**DATE:** 08.22.2018  
**TO:** ProTrak  
**FROM:** Mitesh Baxi  
Traffic Engineering

■ **RIVERLIGHTS CONVENTIONAL PH V & VI [Subdivision Plan Review]**

☞ Initial Review Note ☞

# Riverlights Conventional Ph 5 & 6 Standard Street Lighting Plan

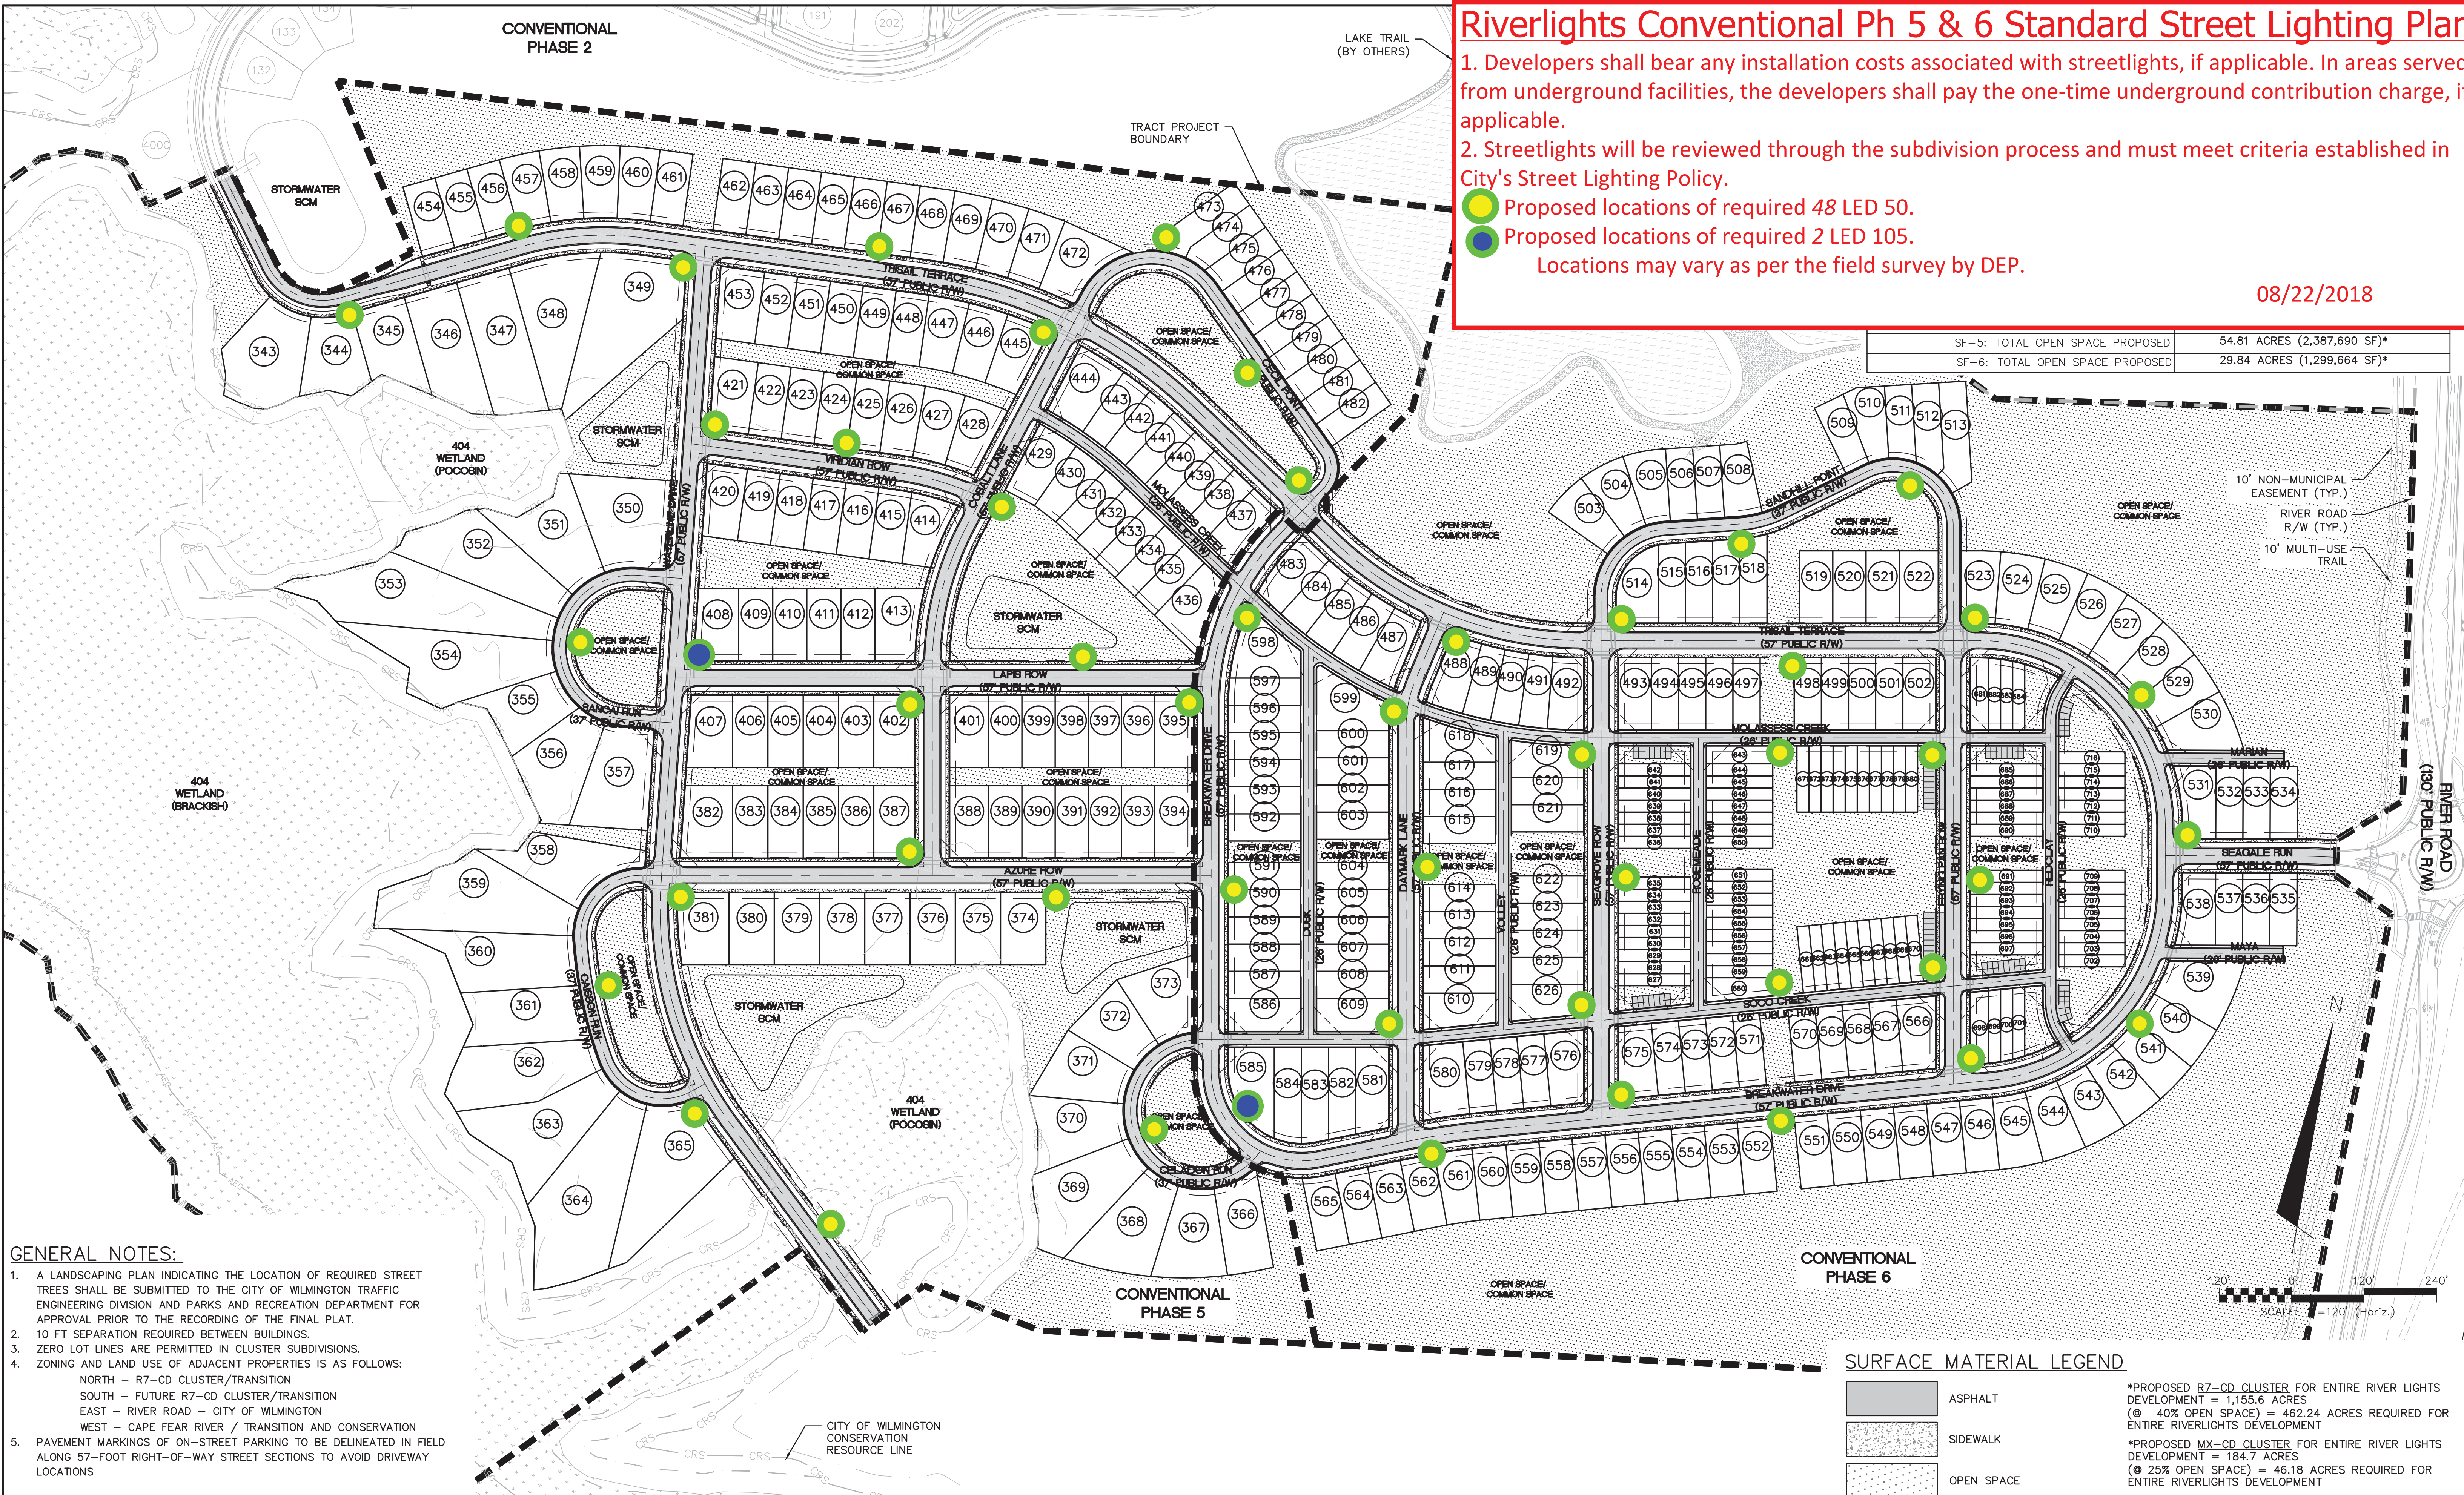
2. A layout for the Standard street lighting has been provided with the review. Minimum of 48 (forty eight) street lights are required for this sub-division. Although, developers may choose to provide any extra lights or ornamental. Any installations above the criteria of Standard street lighting, will be considered as non-standard and has to conform to the City's non-standard street lighting procedure as per the policy.

1. Developers shall bear any installation costs associated with streetlights, if applicable. In areas served from underground facilities, the developers shall pay the one-time underground contribution charge, if applicable.
  2. Streetlights will be reviewed through the subdivision process and must meet criteria established in City's Street Lighting Policy.
- Proposed locations of required 48 LED 50.
  - Proposed locations of required 2 LED 105.
- Locations may vary as per the field survey by DEP.
